# LOYOLA FLATS

**6700 DECKER LANE, 78724  
SP-2024-0147C.SH**

# VARIANCE REQUEST

## LDC 25-8-261(G) – CRITICAL WATER QUALITY ZONE DEVELOPMENT

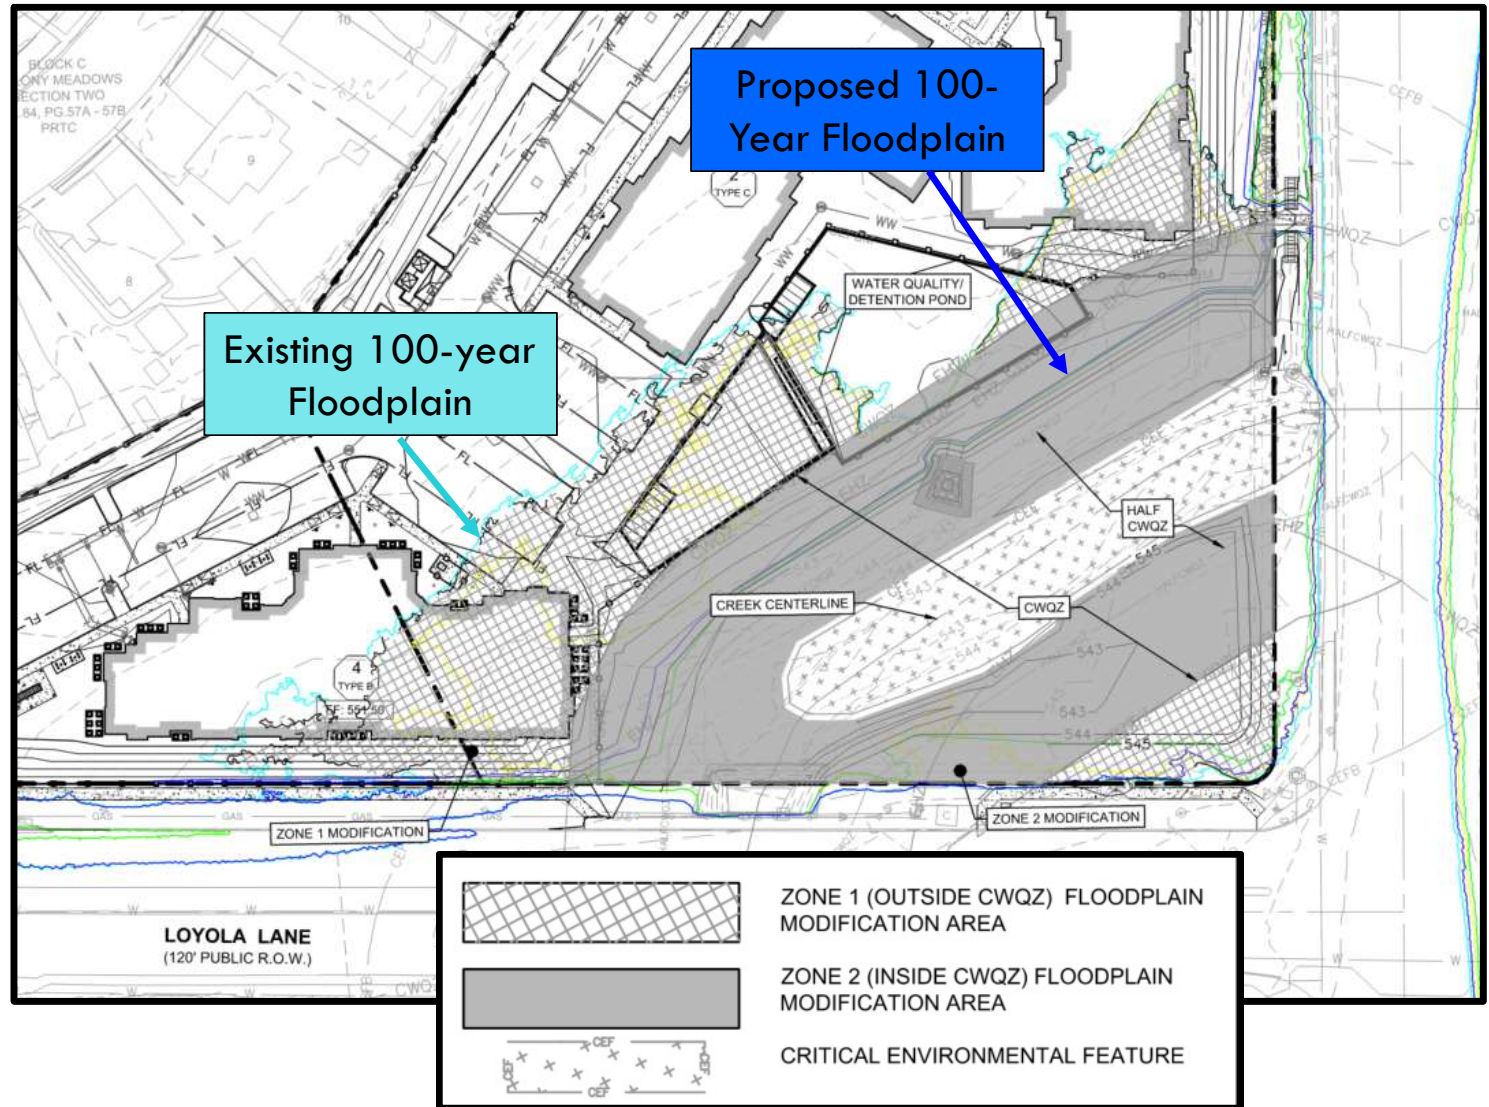
Floodplain modifications prohibited in the CWQZ unless one of the exemptions is met.

1. The variance request is to allow floodplain modification for development within the CWQZ.

## Functional Assessment of Floodplain Health

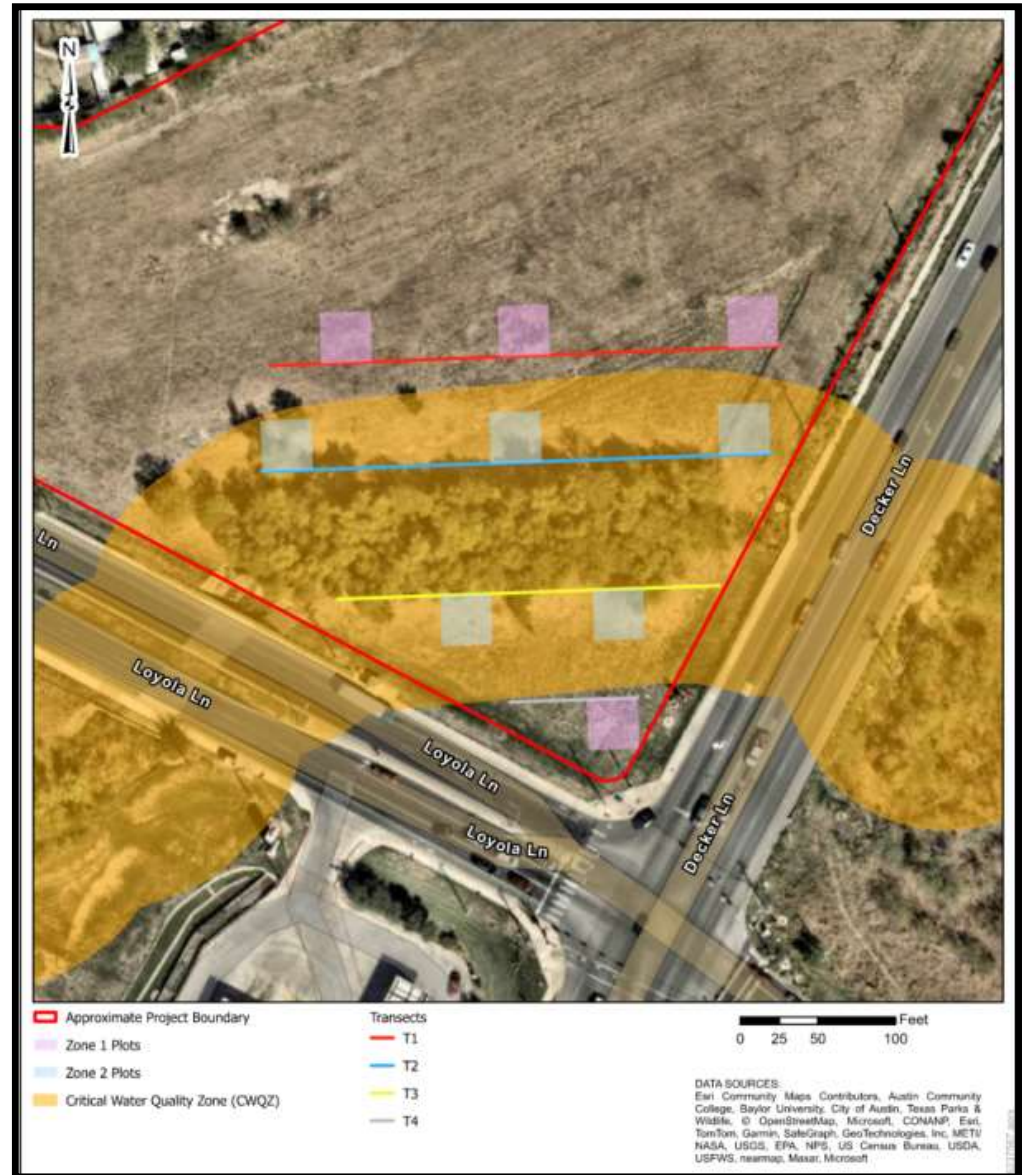
- Floodplain is in “Fair” condition
- Excellent → Good → Fair → Poor

Floodplain Restoration/Mitigation Ratios ECM 1.7.5 & ECM 1.7.6

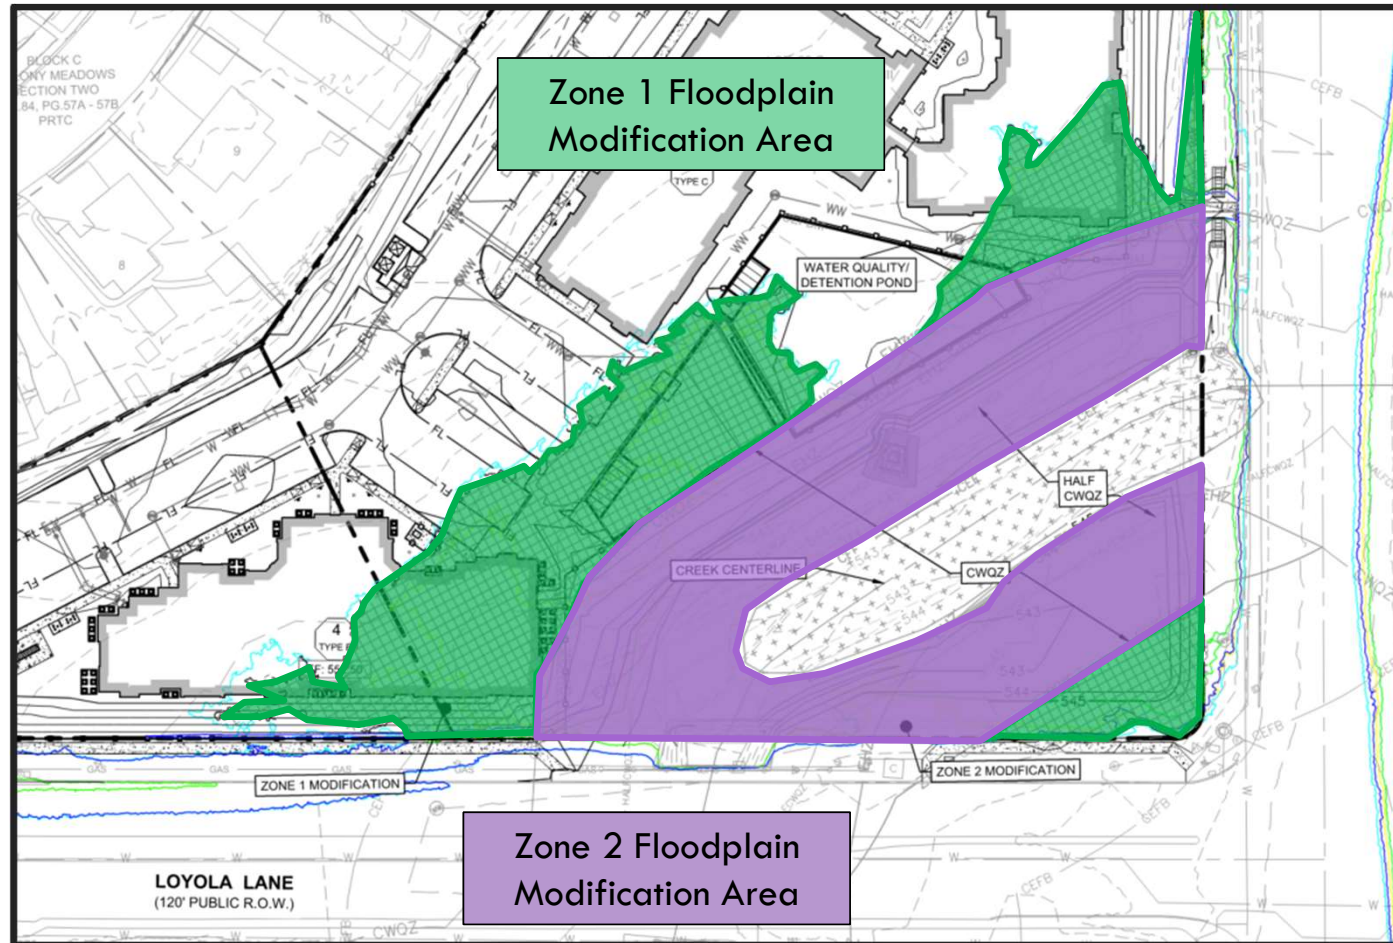
- Total Modification Area: 1.96 acres
- Zone 1 (Floodplain outside the CWQZ)
  - 0.84 acres
  - FAIR 3:1
    - 2.52 acres (Required Restoration/Mitigation)
- Zone 2 (Floodplain within the CWQZ)
  - 1.12 acres
  - FAIR 6:1
    - 6.72 acres (Required Restoration/Mitigation)
- **Total Required Restoration and/or Mitigation Area: 9.24 acres**

## Floodplain Restoration/Mitigation Ratios ECM 1.7.5 & ECM 1.7.6

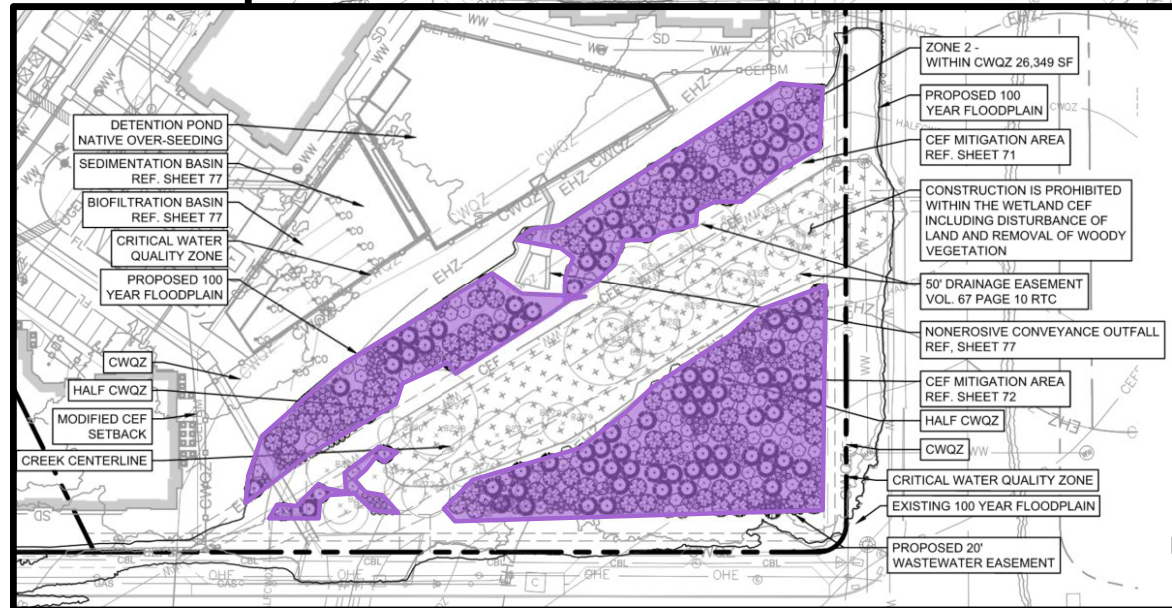
- Total Required Restoration and/or Mitigation Area: **9.24 Acres**
- Zone 1 (Floodplain outside the CWQZ)
  - 2.52 acres
    - 0 acres (Restored)
    - 2.52 acres (Mitigated)
- **Zone 2 (Floodplain within the CWQZ)**
  - 6.72 acres
    - 0.61 acres (Restored)
    - 6.11 acres (Mitigated)
- **Total Restoration Area: 0.61 Acres**
- **Total Mitigation Area: 8.63 Acres**
  - \$382,157.63 Riparian Zone Mitigation Fund payment

## Enhancements

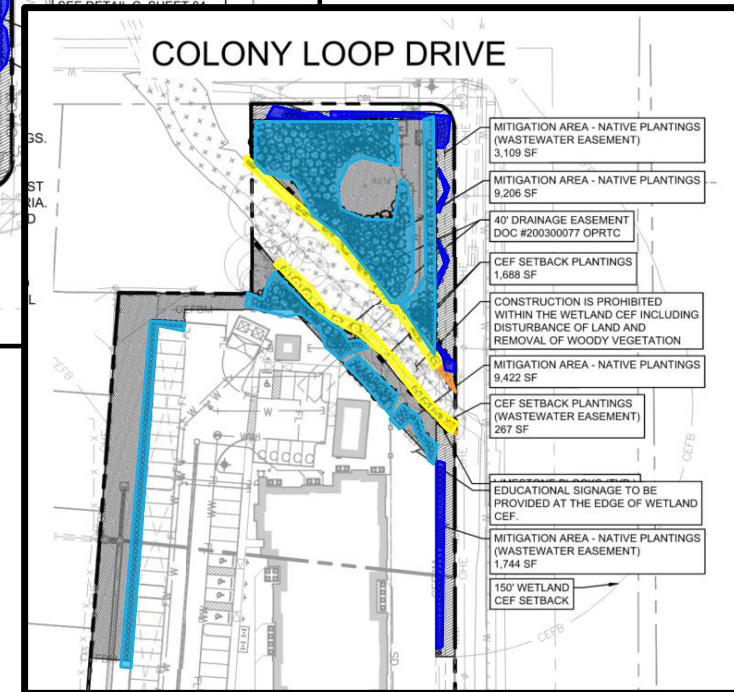
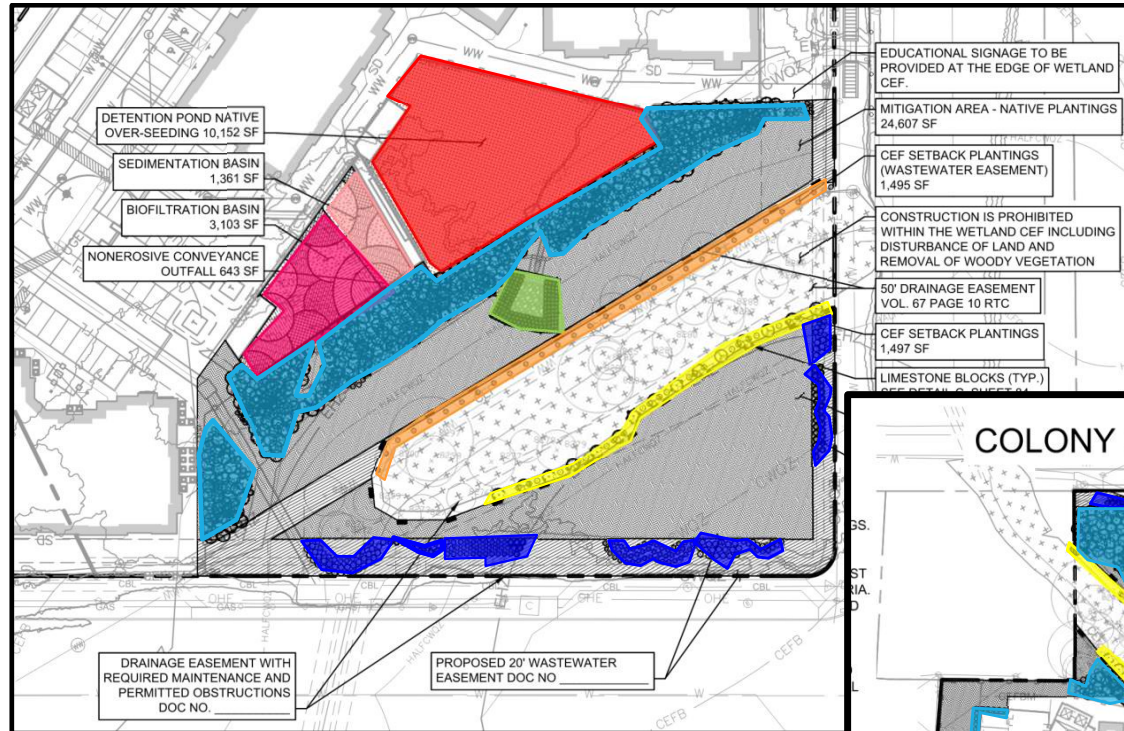
- ~44,000 sq ft of additional wetland mitigation
- Native plantings in biofiltration pond
- Native seeding in detention pond
- Enhanced outfall
- Native trees, shrubs, and bunchgrasses in CEF setbacks & mitigation areas
- Native pollinator species
  - Wetland CEF mitigation plantings
  - Floodplain restoration plantings

1. Provide ~44,000 square feet of additional wetland mitigation including: 1) native plantings in sedimentation and filtration basins of the biofiltration pond, 2) low-grow native seeding in the detention pond, 3) an enhanced nonerosive pond outfall, 4) planting of native trees, shrubs and bunchgrasses in CEF setbacks and mitigation areas. The Director of WPD may reduce this requirement administratively to allow for a future trail connection to Colony Loop Drive.
2. Provide native pollinator species for wetland CEF mitigation and floodplain restoration plantings.
3. Provide an edge barrier of limestone blocks around the perimeter of the modified CEF setbacks/restoration areas to prevent mowing and/or encroachment in these areas.

## Enhancements:

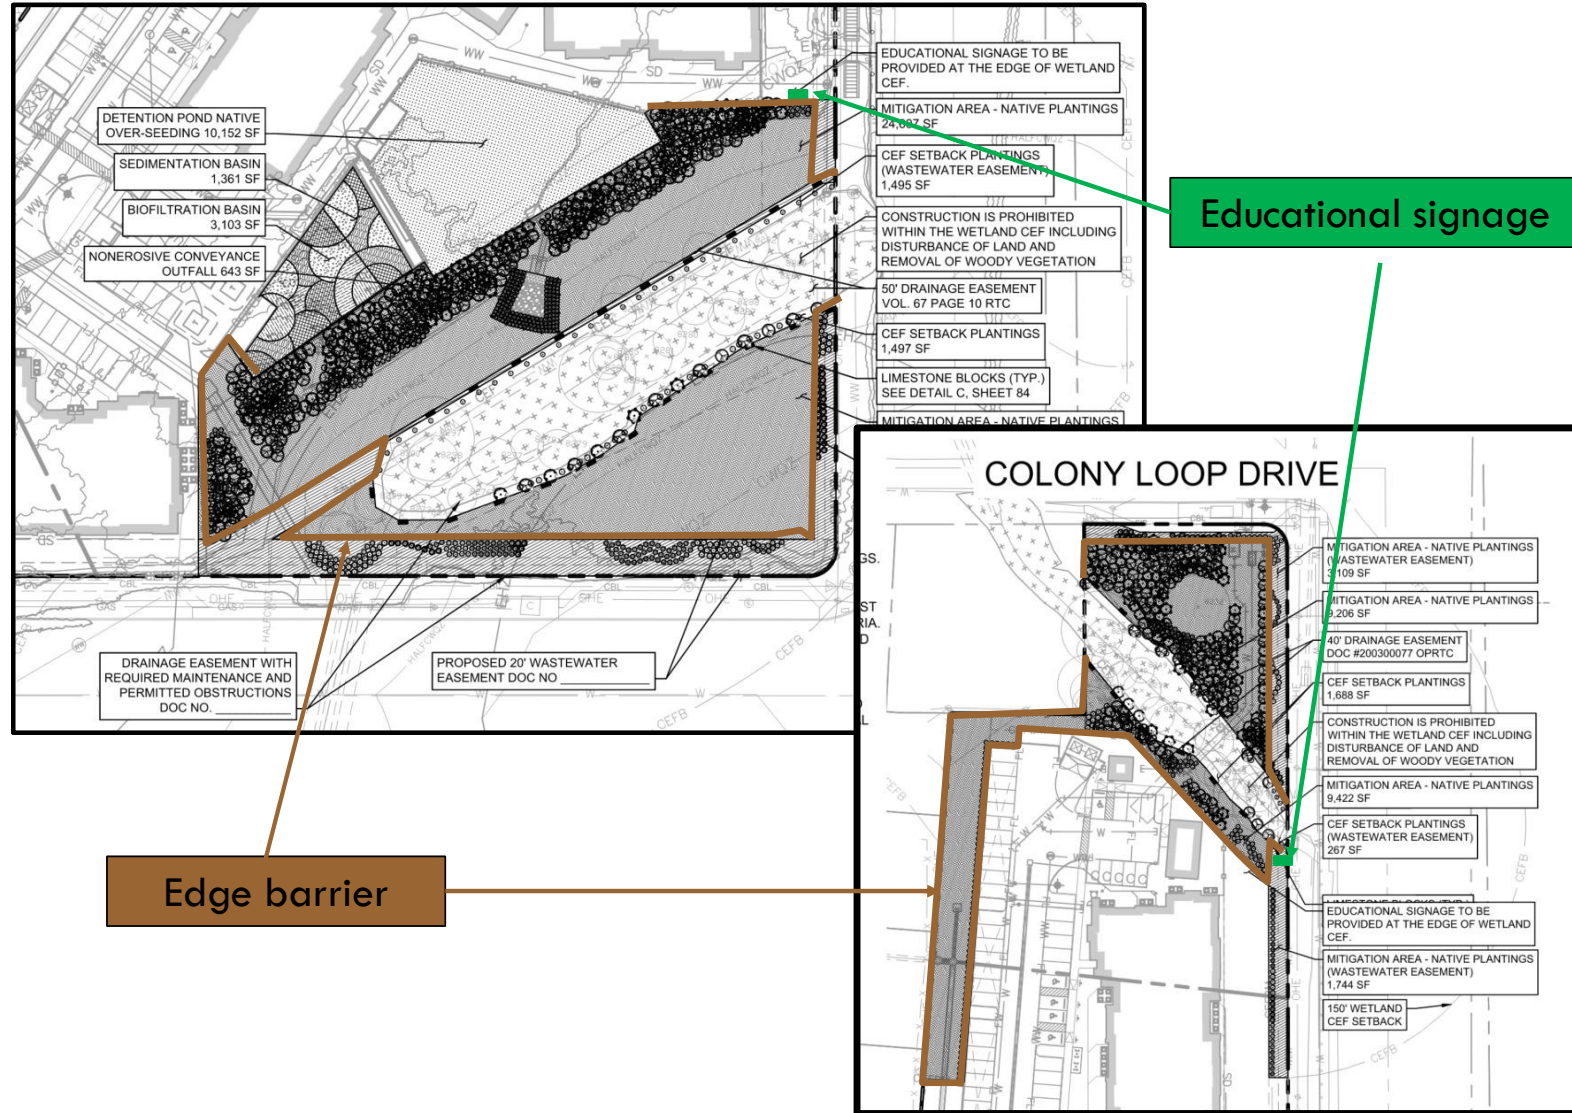
- Edge barrier of limestone blocks around perimeter of modified CEF setbacks/restoration areas
- Wetland CEF educational signage

4. Provide wetland CEF educational signage next to the CEF setbacks/restoration areas.
5. Provide floodplain restoration plantings of native trees and shrubs for the remaining open area (26,349 square feet/0.61 acres) maximizing restoration within the CWQZ and enhancing the floodplain from an existing condition of Fair to Excellent.
6. Pay \$382,157.63 into the Riparian Zone Mitigation Fund for the remaining required floodplain mitigation (376,326 square feet/8.63 acres) using the appropriate ratios per ECM 1.7.6.
